City of Bend Water Reclamation Facility (WRF) Secondary Expansion Value Engineering Report

City Project No: SW0802

SEPTEMBER 2009

Figure 6.1 Existing Aeration Basin Configuration and Flow Distribution

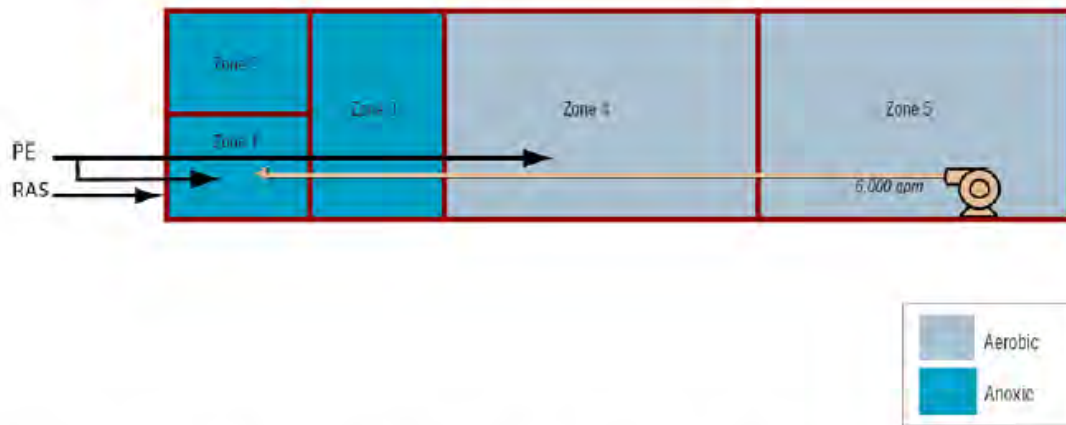
The existing “step-feed” piping for peak wet weather treatment allows some primary effluent to be diverted to Zone 4 but the pipe is undersized at only 12 inches in diameter.

SVI Control

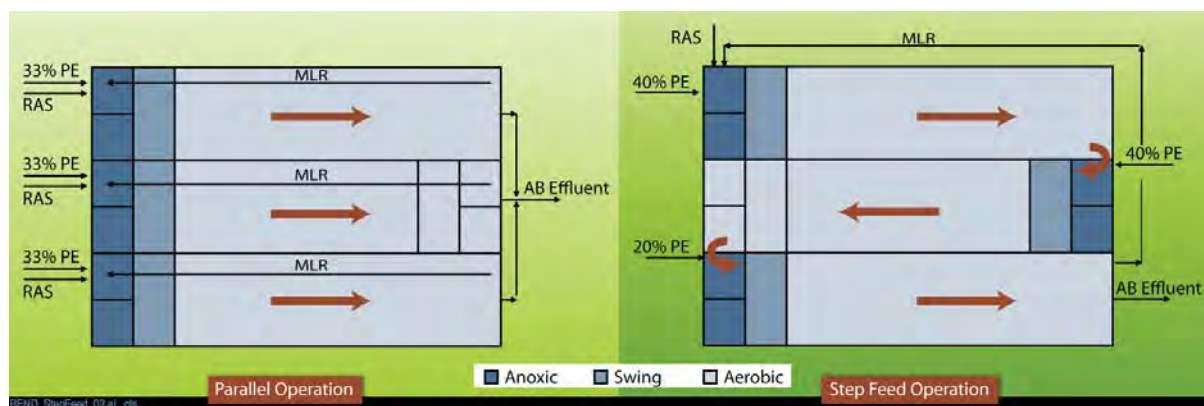
A biological approach to controlling *M. parvicella* is proposed, with the goal of reducing the overall SVI within the system to improve secondary capacity. We would like to incorporate a system where a targeted aeration zone is utilized to control *M. parvicella* growth, based on the findings from WERF Project 01-CTS-4 and 4a (2006, 2008). Research has demonstrated that a selector, by itself, does not control *M. parvicella*; selectors remove dissolved organic matter, not particulate and colloidal matter. The region just downstream of the anoxic environment is typically low in dissolved oxygen because traditional aeration systems do not elevate this level fast enough. With the particulate and colloidal "food" passing through the selector, an ideal environment for the growth of *M. parvicella* is created.

The aeration system in the bioreactors can be reconfigured to generate an independent aeration zone, having a consistent and relatively high aeration rate, just downstream of the anoxic zone. The aeration control system would be designed to provide the required dissolved oxygen to this independent aeration zone, and would not be affected by other oxygen demands in the system. This high aeration zone can be appropriately sized based on the predictability of biological growth, availability of particulate and colloidal organic matter, and correlations between organism respiration rate and required dissolved oxygen.
